ADDENDUM NO. 3

Reference: Student Activity Center Addition to the Stromberg Athletic Complex
Weber State University – Ogden, Utah
DFCM Project No. 12031810

Addendum 003

project:	WSU Stromberg Student Activity Center	**project no:**	12475
date:	2012-10-18	**no. pages:**	77
owner:	DFCM		
contractor:			
bid date:	2012-11-01	**bid time:**	12:00 pm

A1 DEMOLITION WEST ELEVATION

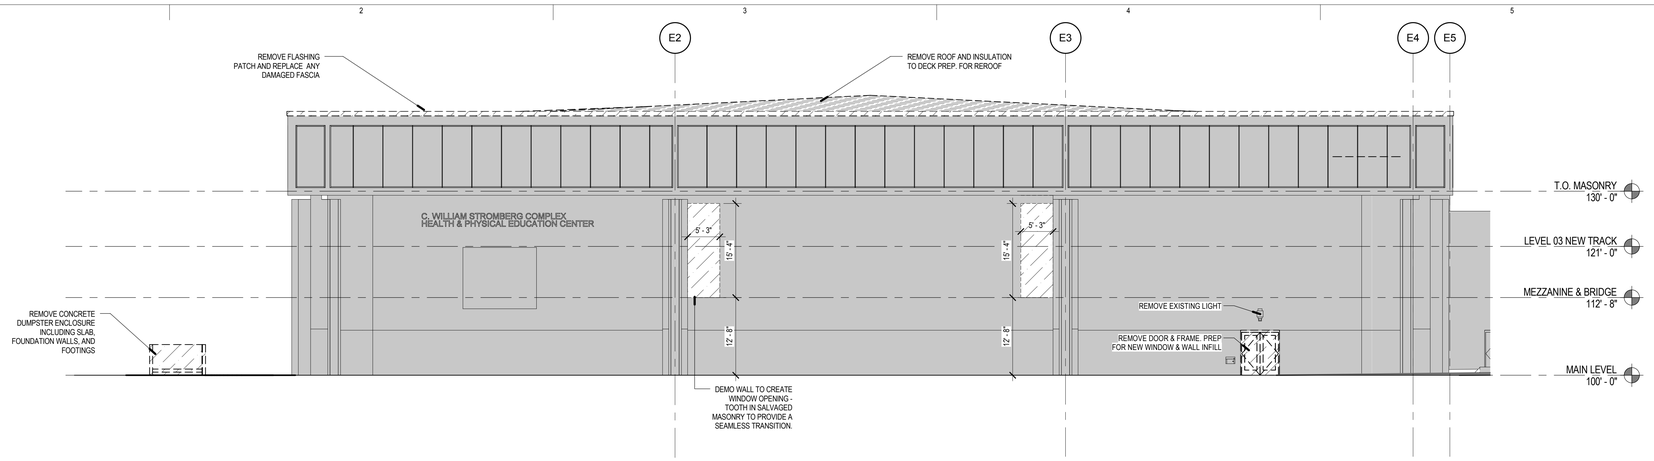
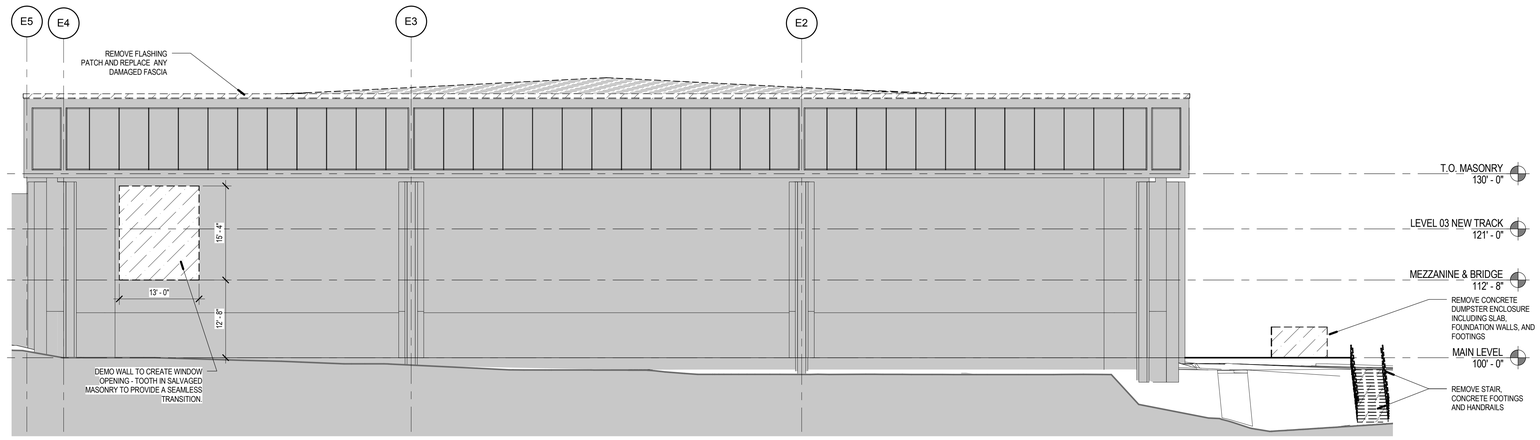
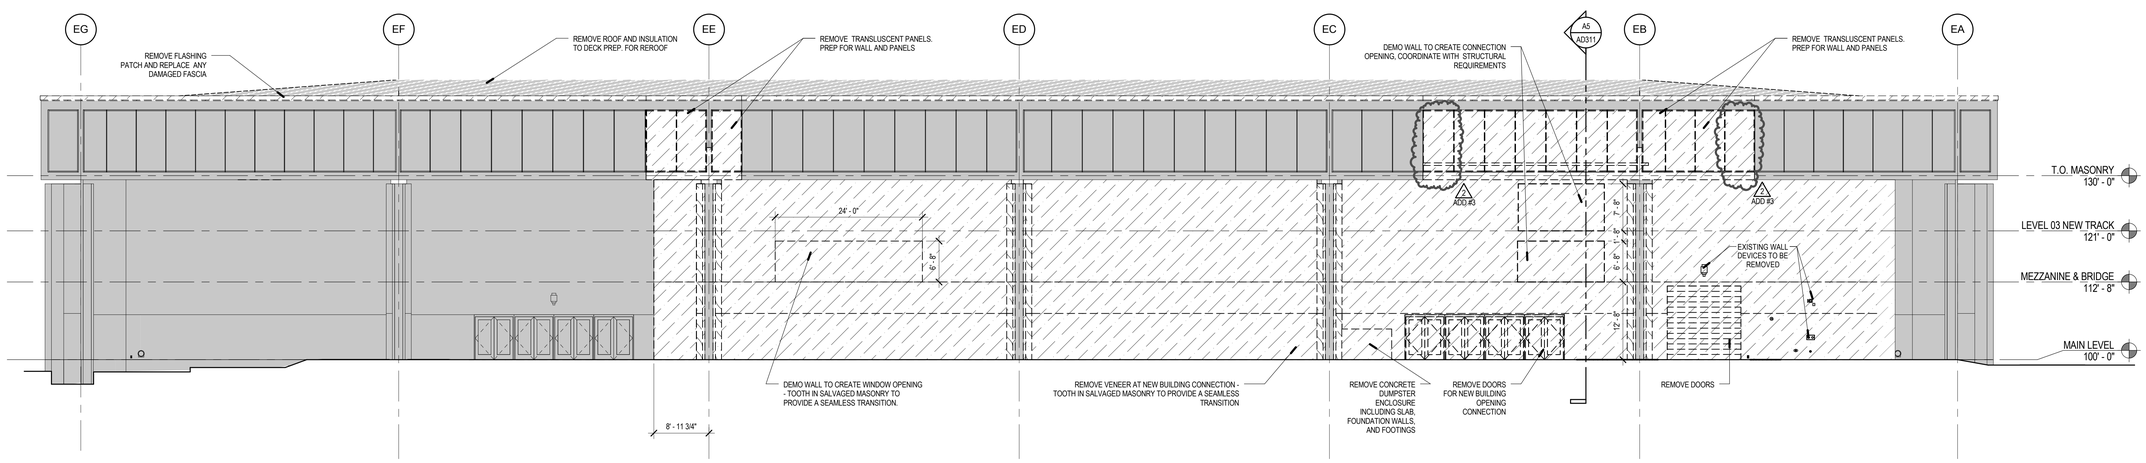
Item	Drawing No	Description
3.1	G001	See attached for revised Index.
3.2	AD201	See attached revised sheet for revised scope of existing translucent wall panel to be demoed at the west elevation.
3.2	AS201	See added detail D3/AS201.
3.3	A104.1	See attached revised roof plan for added detail call outs D1/A531 and E5/A561.
3.3	A111.3	See attached sheet A111.3 for revised finish call outs.
3.4	A112.2	Add card key access to existing door 121A. See attached revised sheet for location and refer to revised hardware change on sheet A600.

A1 LEVEL 01 AREA A - FINISH PLAN

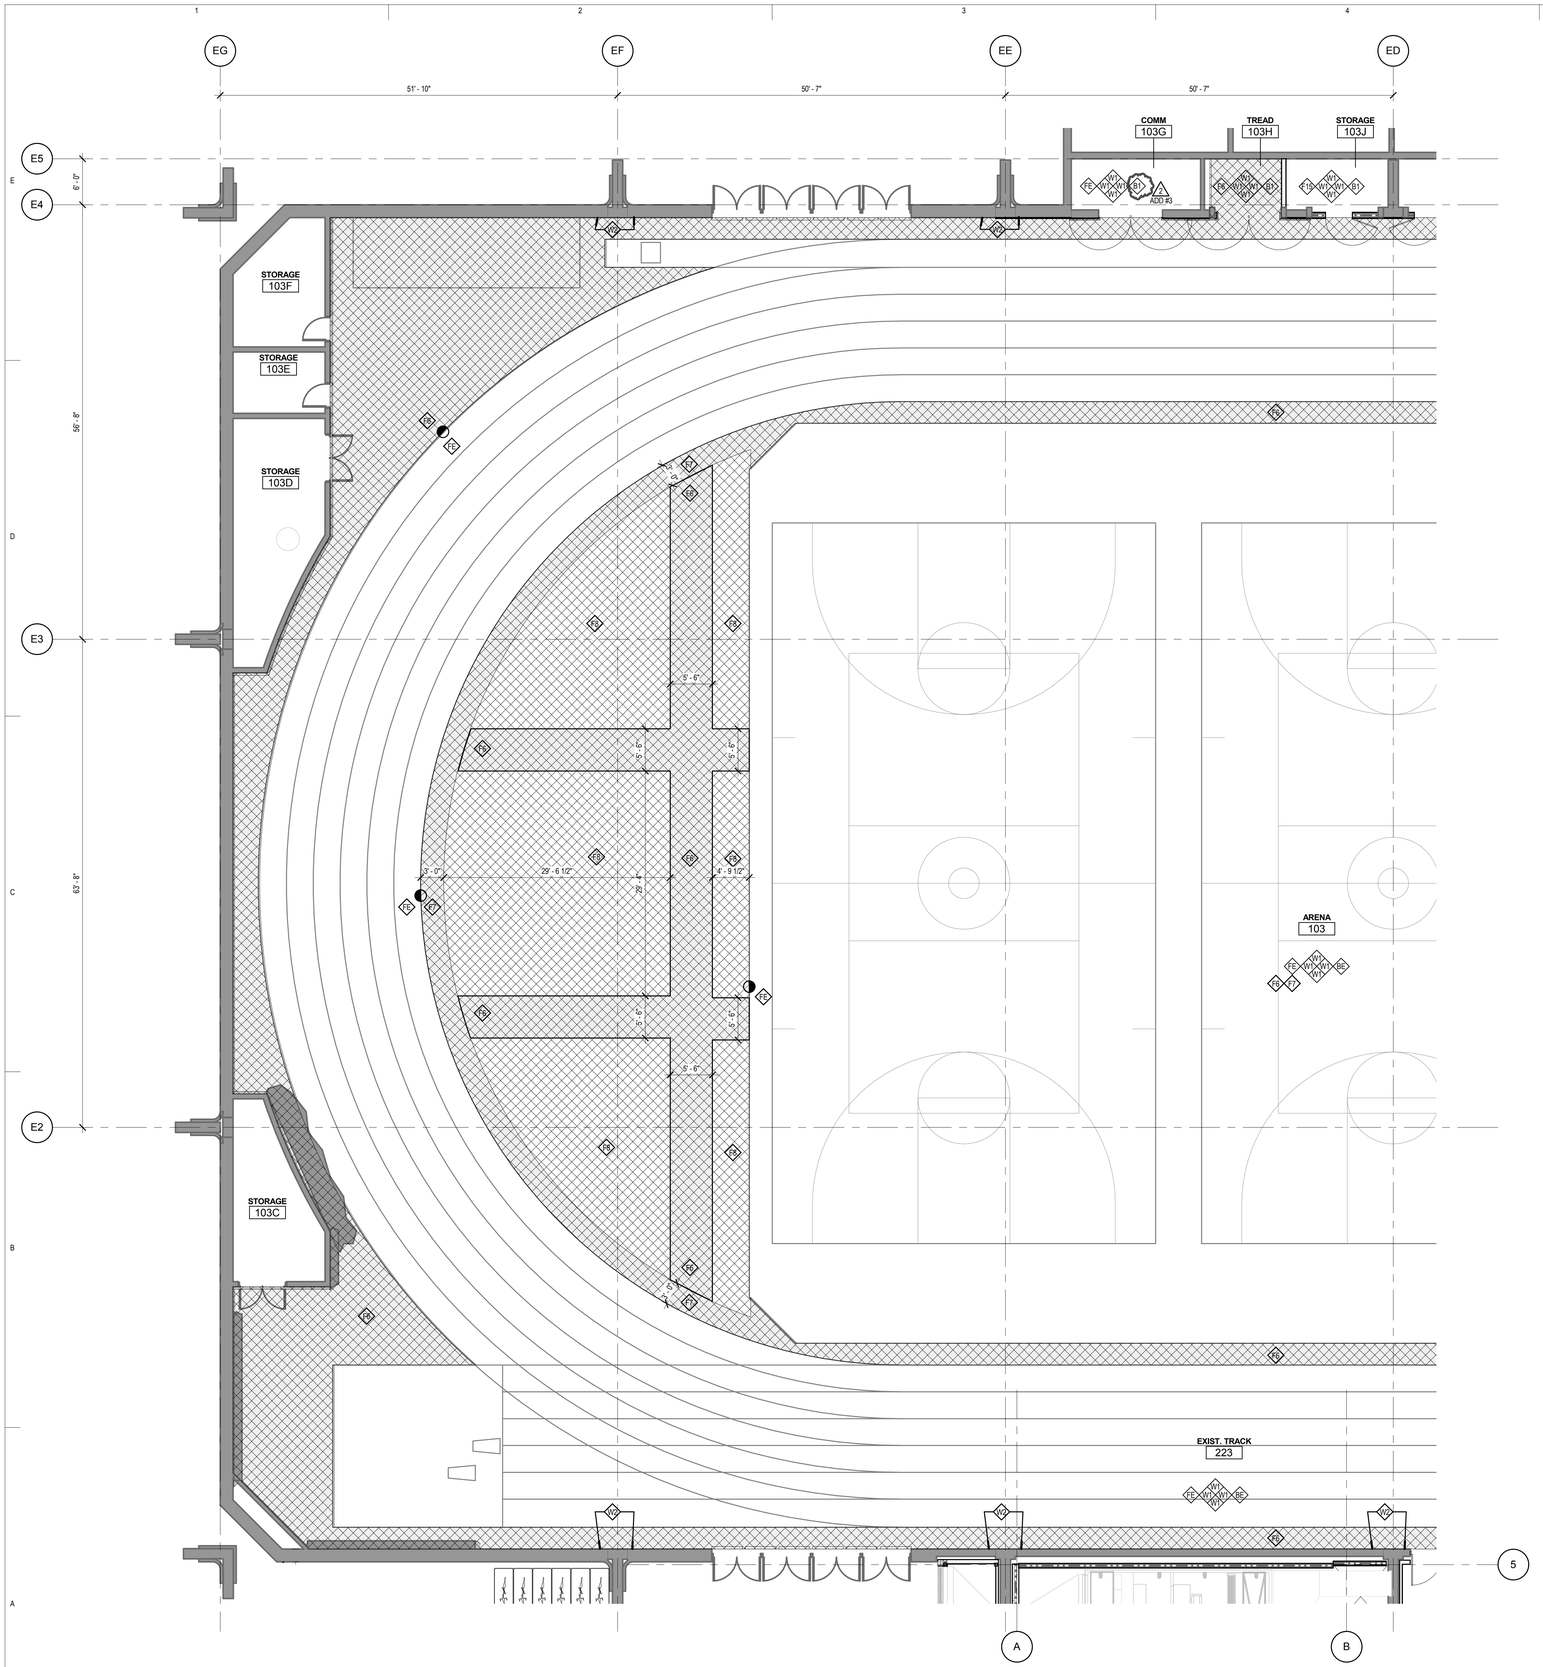
3.5	QUESTION: Please identify note 723 on A104.1 RESPONSE: Keyed note 723 shall read: "SIDEWALL SCUPPER PRIMARY, A3/A530".
3.6	QUESTION: Please provide detail notes for C5&C6 on A531 RESPONSE: Details requested were provided in Addendum #2.

A1 LEVEL 01 AREA B - ANNOTATED PLAN

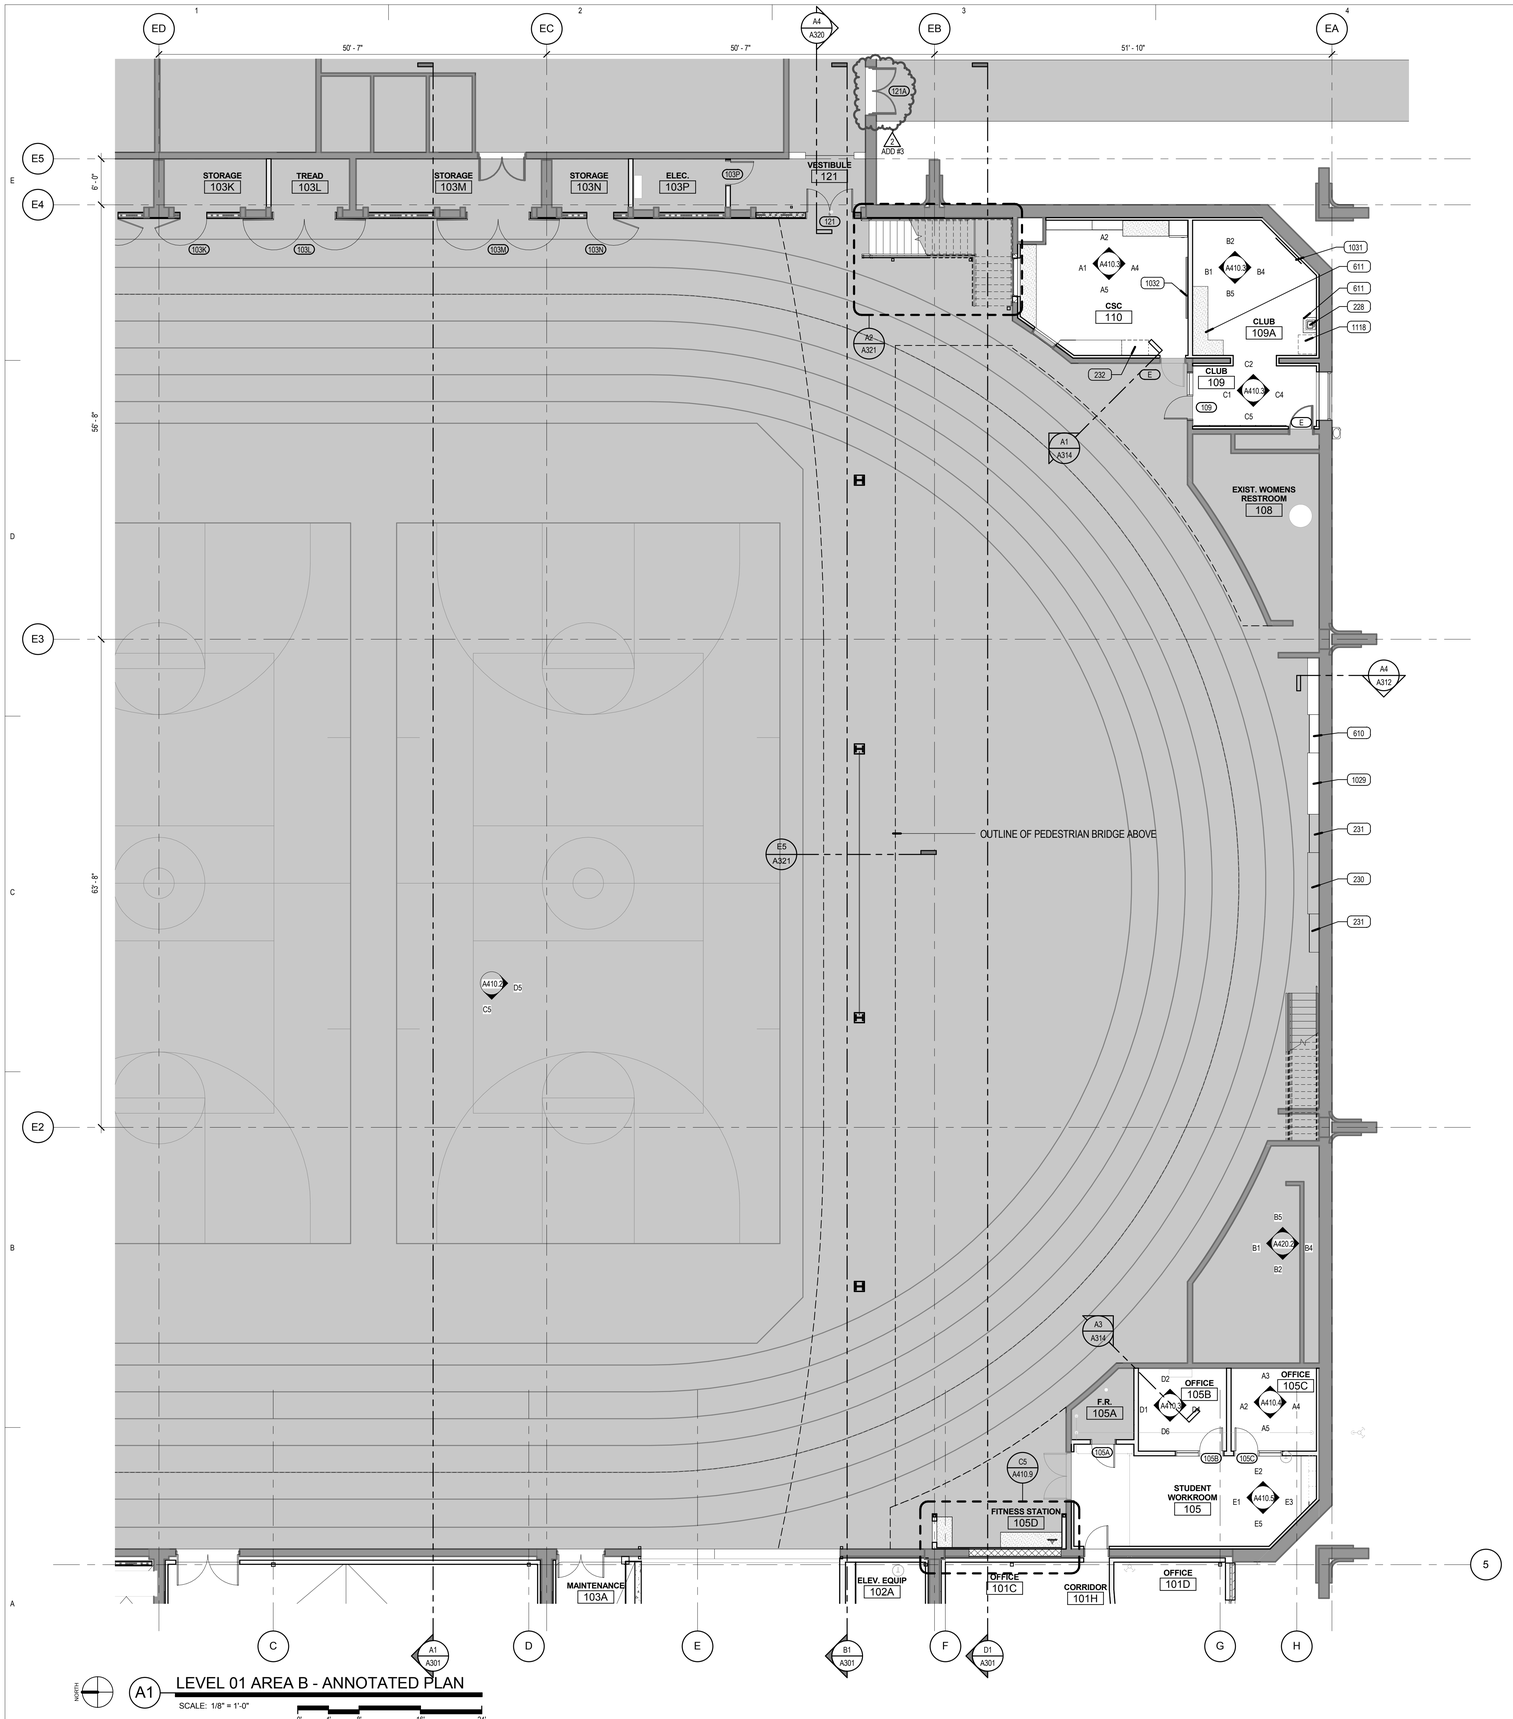
3.8	QUESTION: Comm Room 103G on A111.3 calls for a B6 finish. There is no B6 on the finish schedule. Please provide. RESPONSE: Base finish in Room 103G shall be B1.

3.14	QUESTION: What is B6 materials type or call out? RESPONSE: Where B6 is called out it should read B1, rubber base. See revised sheets A113.3 and A111.3 for revised call outs.

D5 MEN'S 206 ENLARGED PLAN

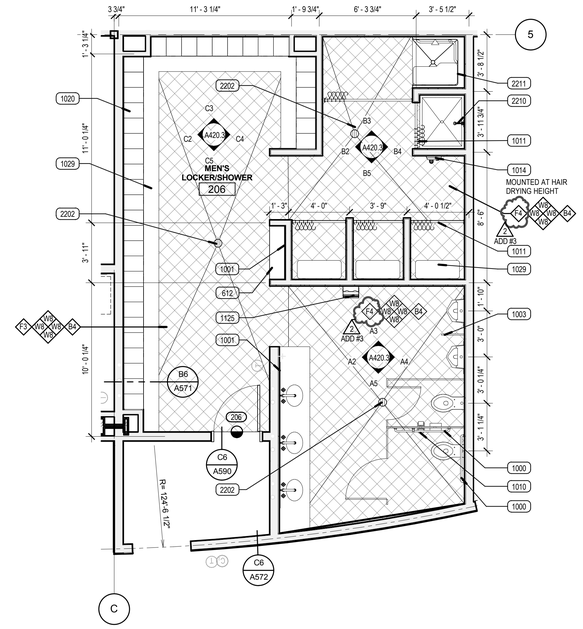
3.4	QUESTION: There are no notes for the details on sheet A320 & 321. Please provide. RESPONSE: Revised sheets A320 and A321 are provided. See attached.

3.9	A201	See attached revised sheet for revised scope of translucent wall panel to be replaced.
3.9	A320	See attached for key noted Sheet A320.
3.8	A321	See attached for key noted Sheet A321.

D1 EXPANSION JOINT @ ROOF STRUTS
SCALE: 1 1/2" = 1'-0"
0' 1/2" 1" 1 1/2"
ADD #3

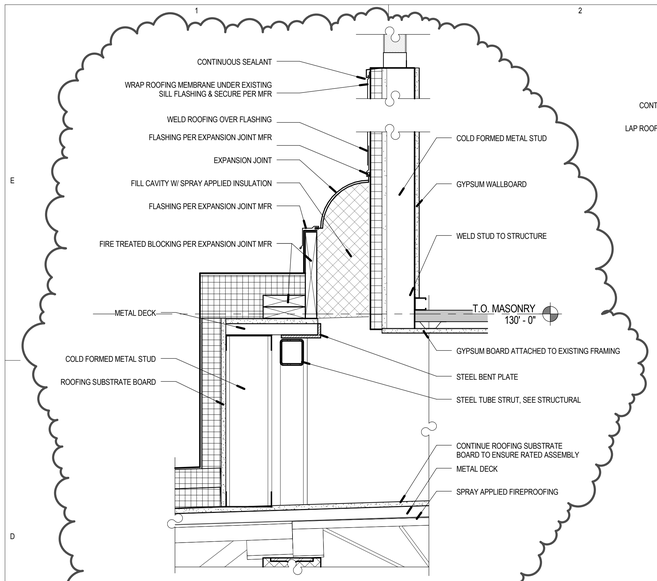
3.5	A420.3	See attached revised sheet.
3.6	A420.7	See attached revised sheet.
3.14	A510	See attached revised sheet for updated detail C3/A510.
3.14	A530	See attached for added detail A3/A530.

E2 BANNER BRACKET DETAIL
SCALE: 1" = 1'-0"

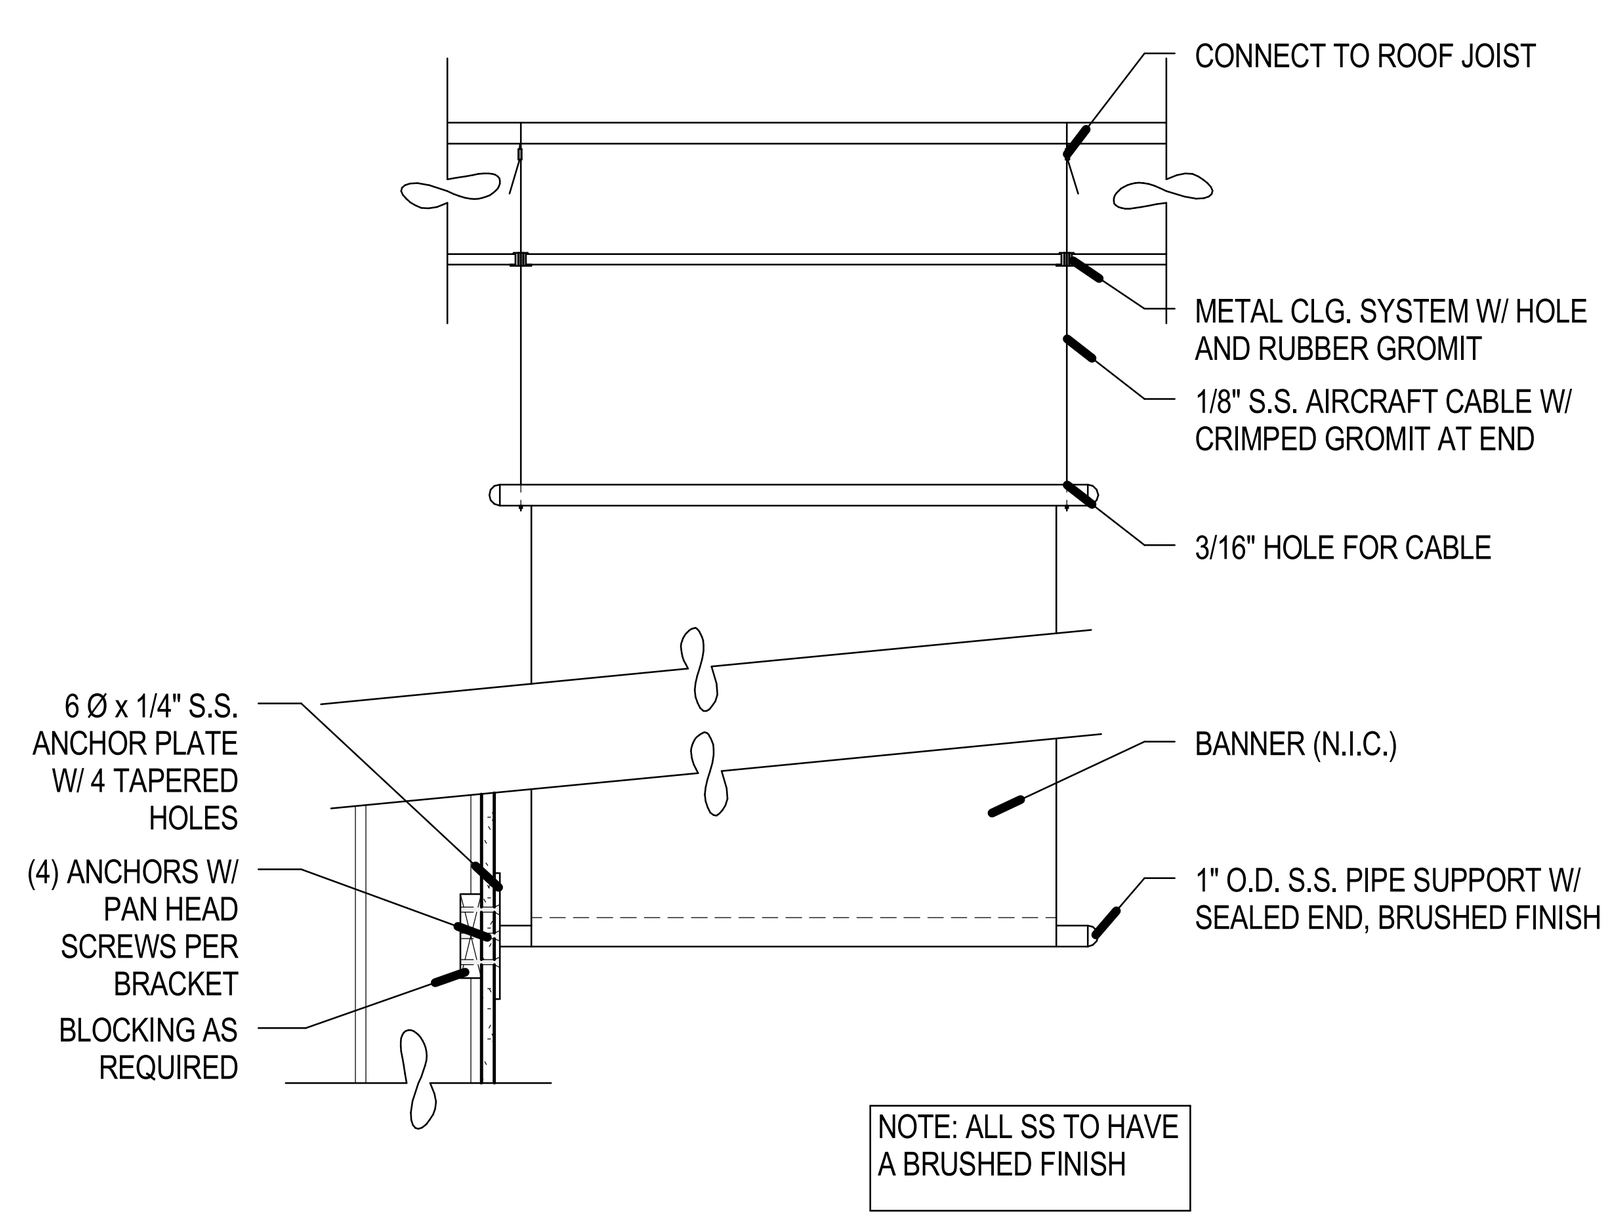
3.18	A562	See attached revised sheet for updated detail E2/A562.
3.18	A572	See attached revised sheet for addition notes on Casework Details: A4, C4 and D4/A572.
